# Wisconsin Department of Transportation

### NOTICE TO ALL CONTRACTORS:

**Proposal #12: 1300-03-72, WISC 2021 140**  
**Lake Parkway – Milwaukee/St. Francis**  
**E Lincoln Ave to S Pennsylvania Ave**  
**STH 794**  
**Milwaukee County**

This is Addendum No. 02, which provides for the following:

Addendum No. 01  
ID 1300-03-72  
Revised Sheet 32  
January 27, 2021

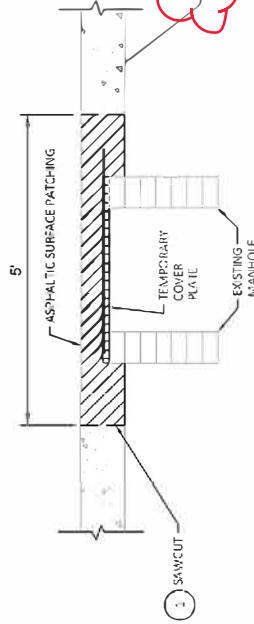
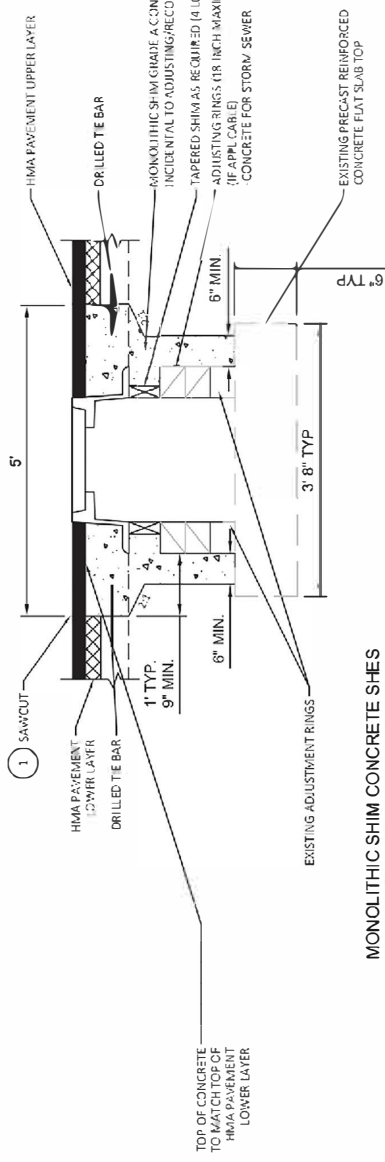
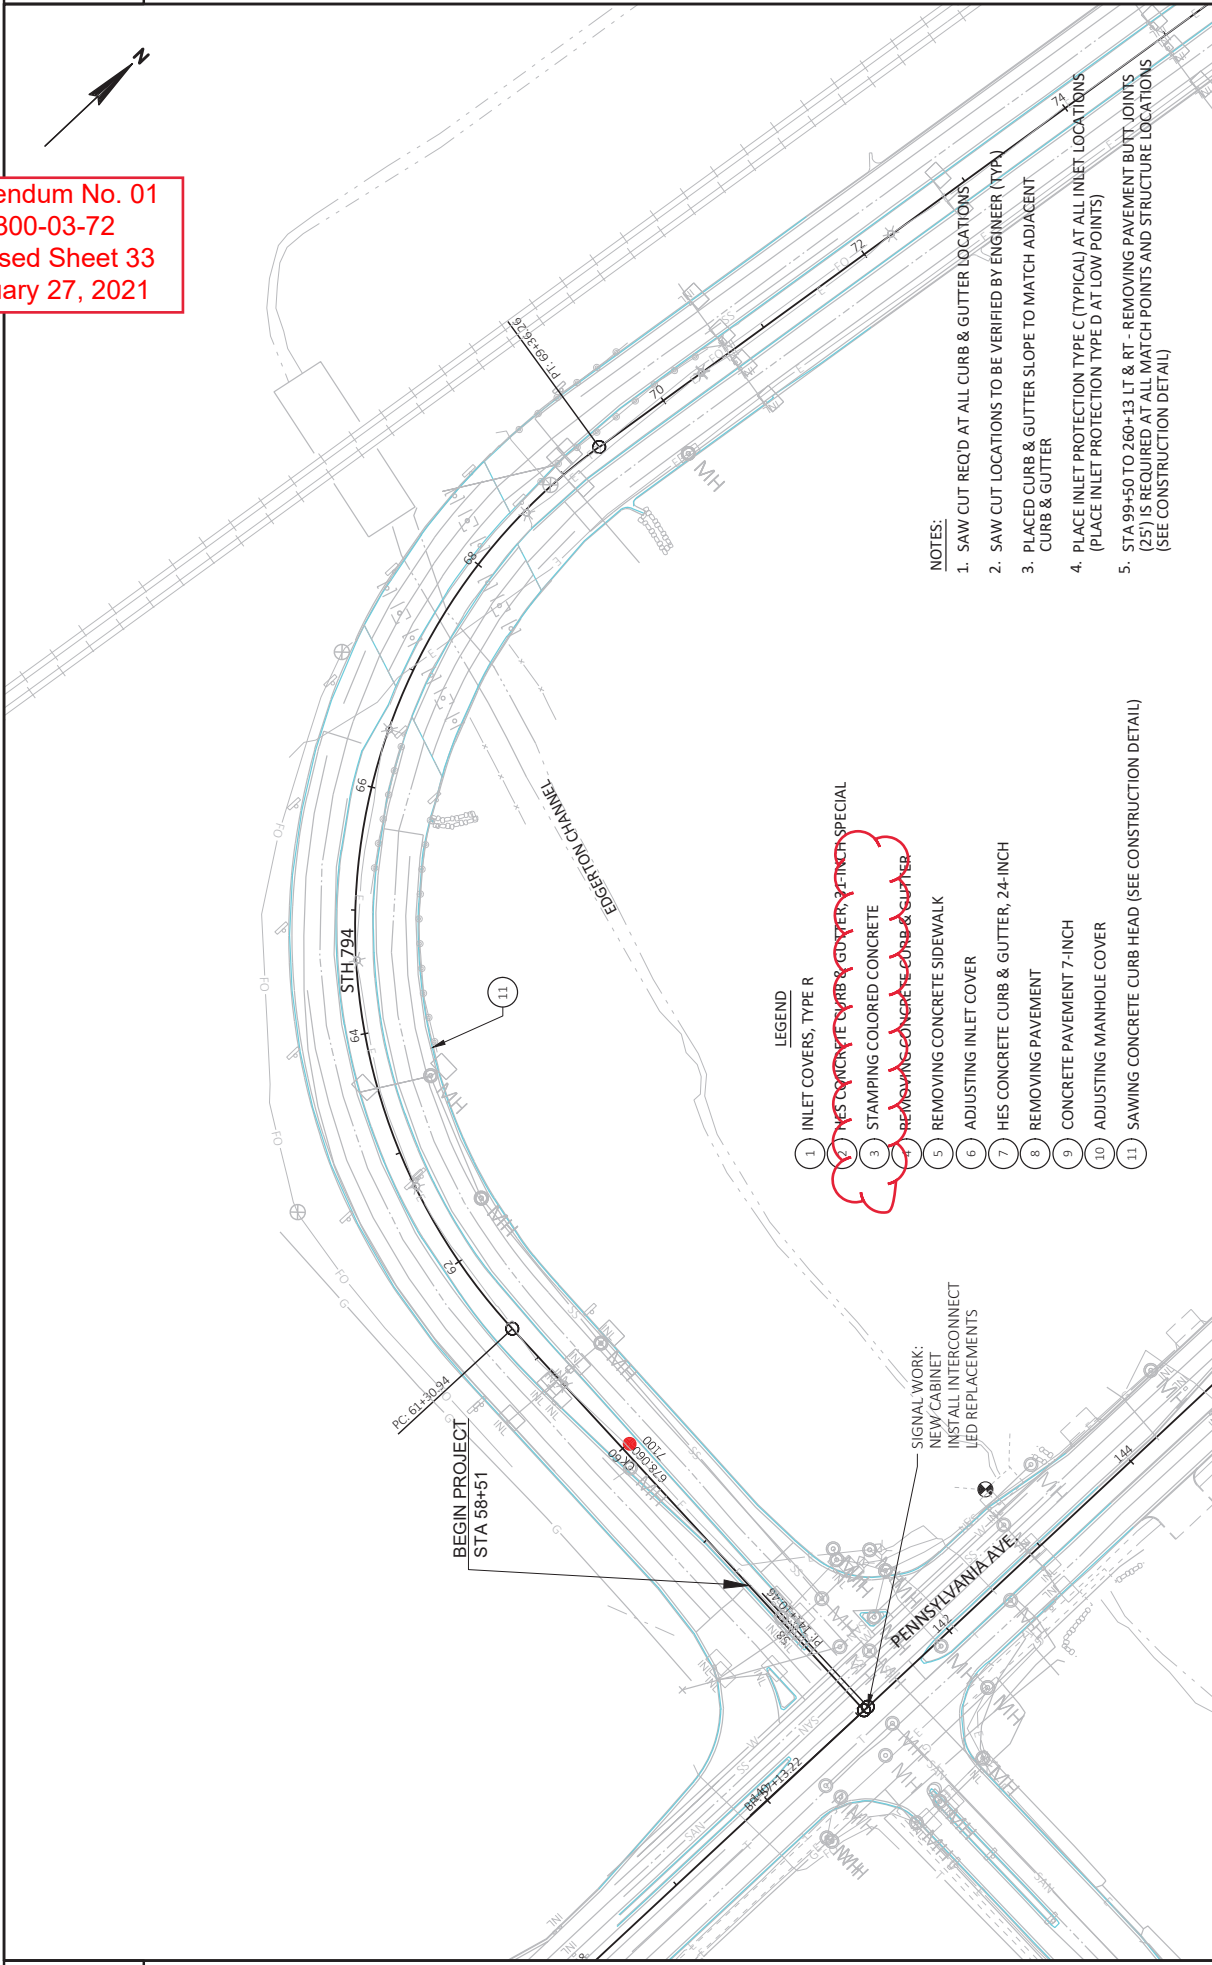
| <b>Revised Plan Sheets</b> |   |
|----------------------------|---|
| 32                         | Construction detail note change item from asphalt patching to asphaltic surface temporary and asphalt depth to match existing pavement structure full depth |

- STEP 1**
- PRIOR TO REPAVING ASPHALTIC SURFACE, PARTIAL DEPTH SAWING (OR REMOVAL) OF ALL COVER FURNISH AND INSTALL TEMPORARY COVER PLATE
  - BACKFILL USING ASPHALTIC SURFACE TEMPORARY

- STEP 2**
- AFTER PAVING LOWER LAYER:
- EXCAVATE AND REMOVE TEMPORARY COVER PLATE
  - ADJUST AND REINSTALL SALVAGED MANHOLE FRAME OR INSTALL NEW CASTING AND COVER USING MONOTONIC CONCRETE SHIM
- ALL WORK EXCEPT ASPHALT PATCHING, SAWING CONCRETE, DRILLED-TIE BARS, AND INSTALLATION REMOVAL OF TEMPORARY COVER PLATE IS INCLUDED IN THE COST OF ADJUSTING MANHOLE COVERS.

Addendum No. 01  
ID 1300-03-72  
Revised Sheet 33  
January 27, 2021

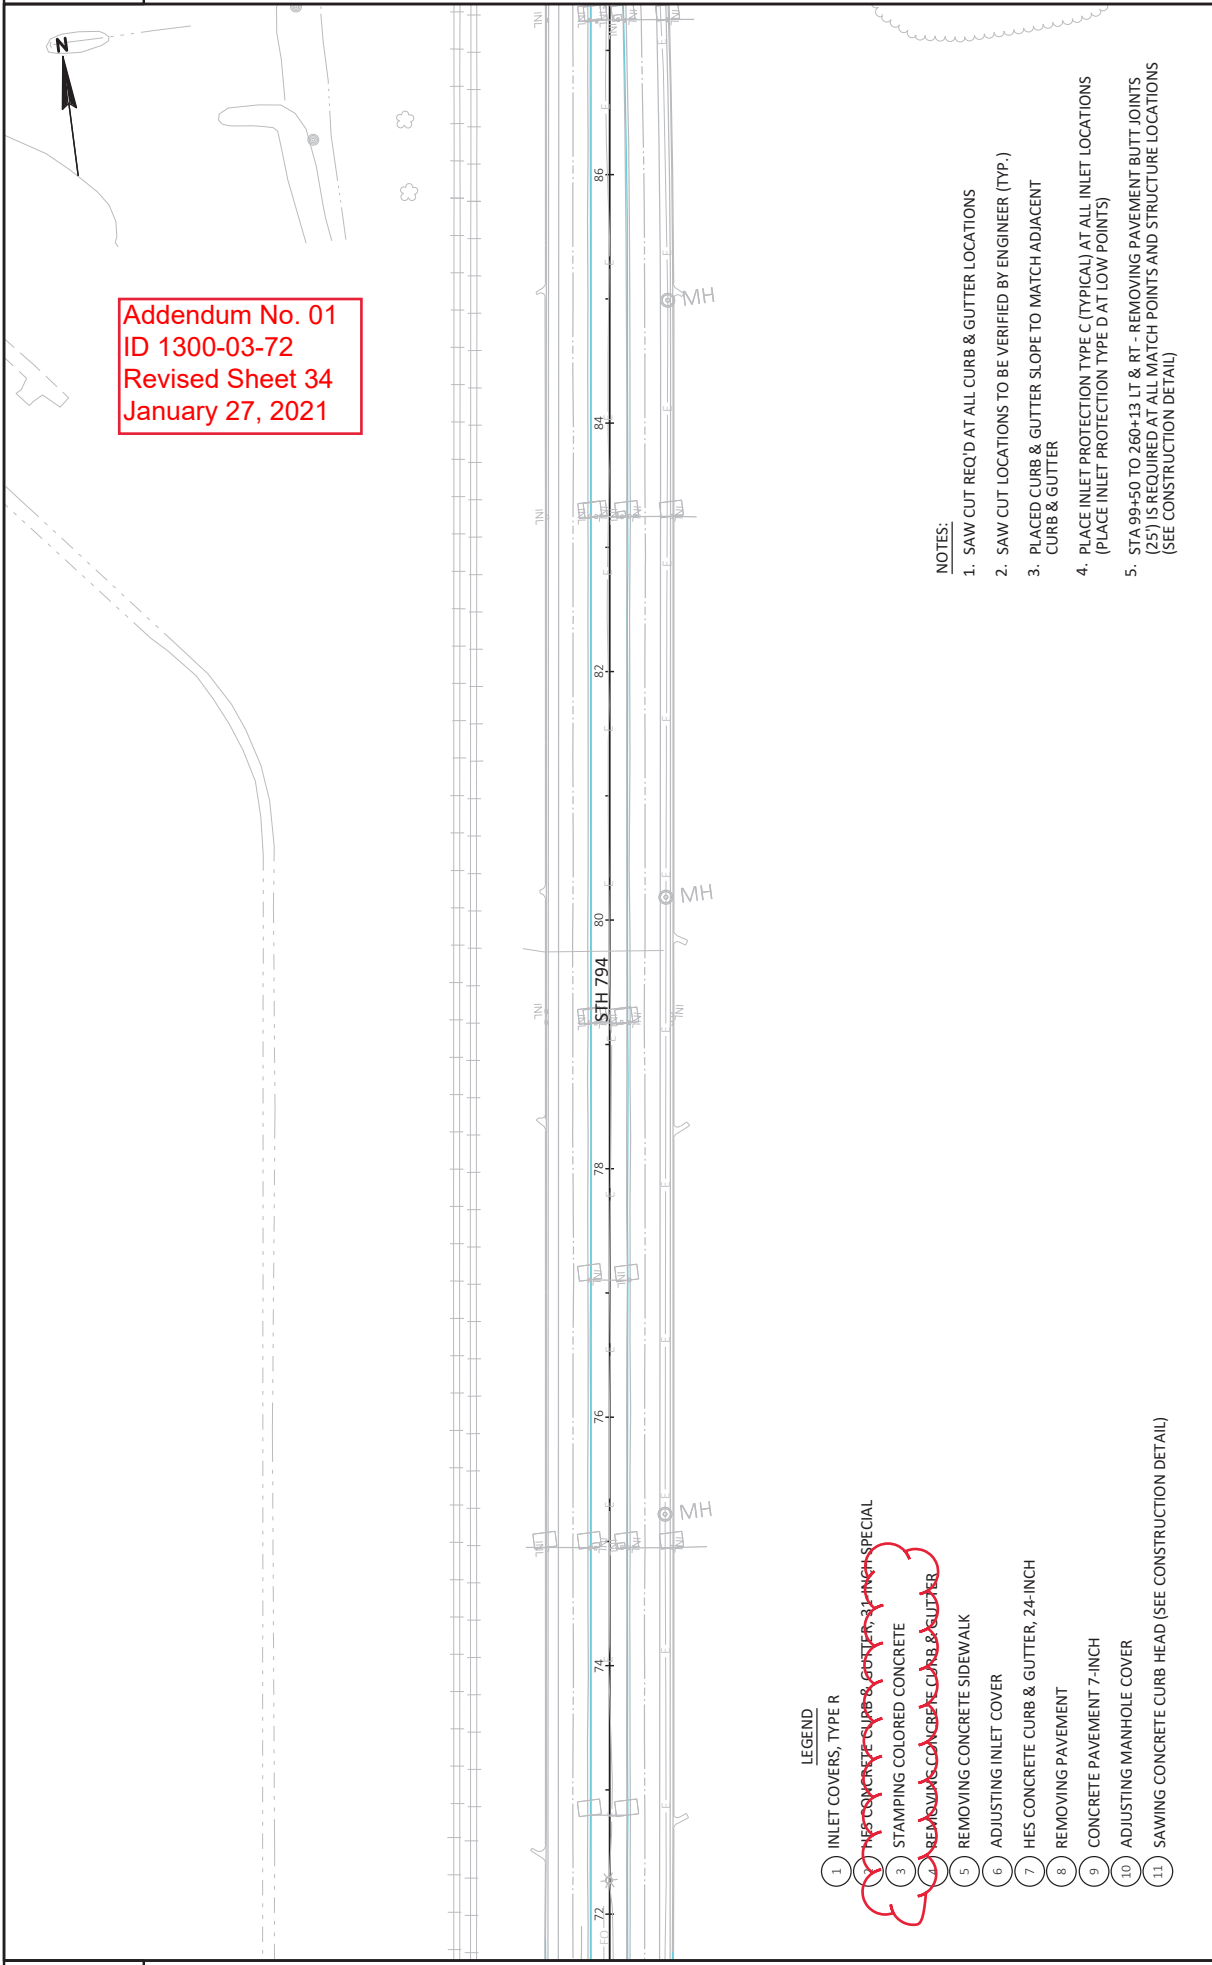
| <b>Revised Plan Sheets</b> |   |
|----------------------------|---|
| 33-46                      | Plan Detail sheet legend updated to remove Concrete Sidewalk 5-Inch and replace with Stamping Colored Concrete  |
